January 1999 doc.: IEEE 802.11-99/023

Comments on P802.11a draft

Masahiro Morikura
morikura@mhosun.wslab.ntt.co.jp
NTT

1.3.8.1 Receiver Minimum Input Level Sensitivity

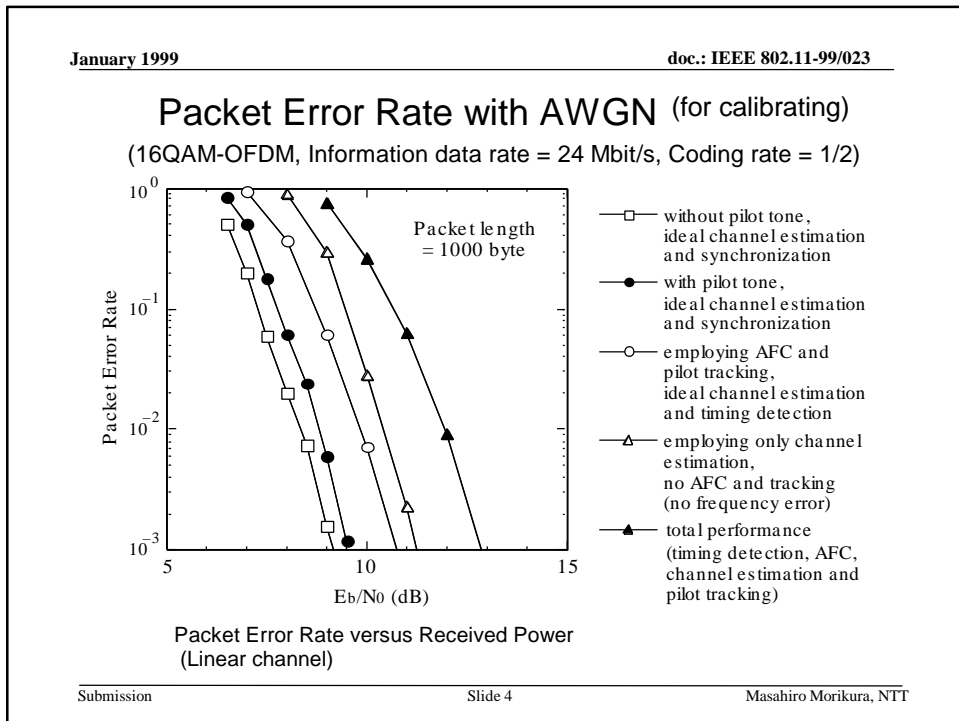
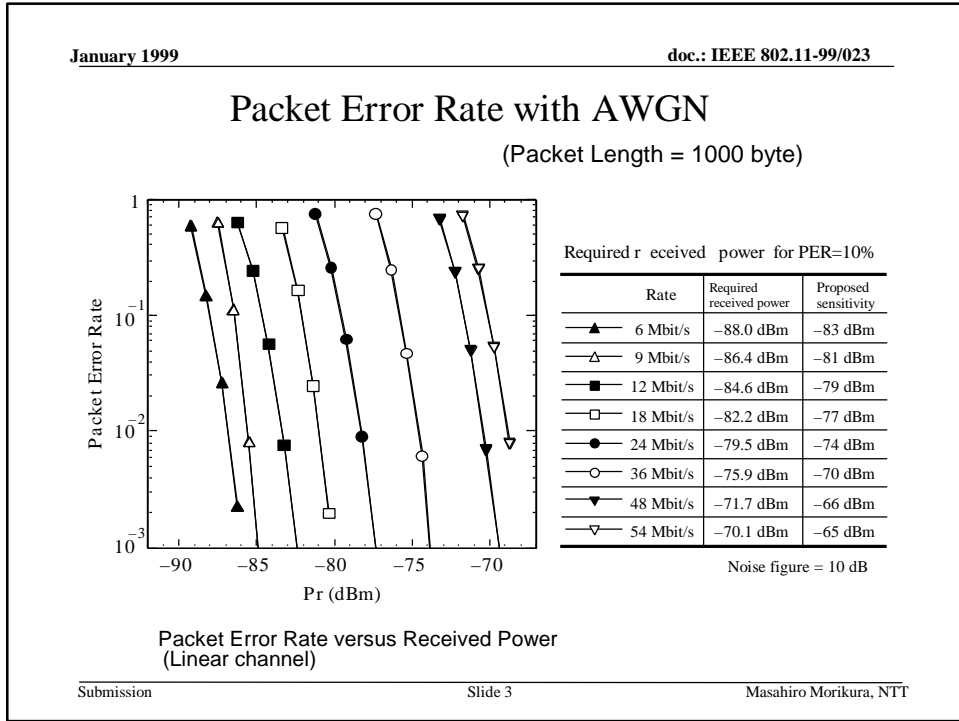
The sensitivity values are specified by adding 5 dB margin to the required received power at 10% packet error rate in the case of 1000 byte MPDU length.

The current values for receiver sensitivity may be derived from the simulation results by using old system parameters.

➔ Re-evaluation is required.

- The values of receiver minimum input level sensitivity are recommended to change as the following

Rate	Required received power	Proposed sensitivity
6 Mbit/s	-88.0 dBm	-83 dBm
9 Mbit/s	-86.4 dBm	-81 dBm
12 Mbit/s	-84.6 dBm	-79 dBm
18 Mbit/s	-82.2 dBm	-77 dBm
24 Mbit/s	-79.5 dBm	-74 dBm
36 Mbit/s	-75.9 dBm	-70 dBm
48 Mbit/s	-71.7 dBm	-66 dBm
54 Mbit/s	-70.1 dBm	-65 dBm

Assumed noise figure = 10 dB
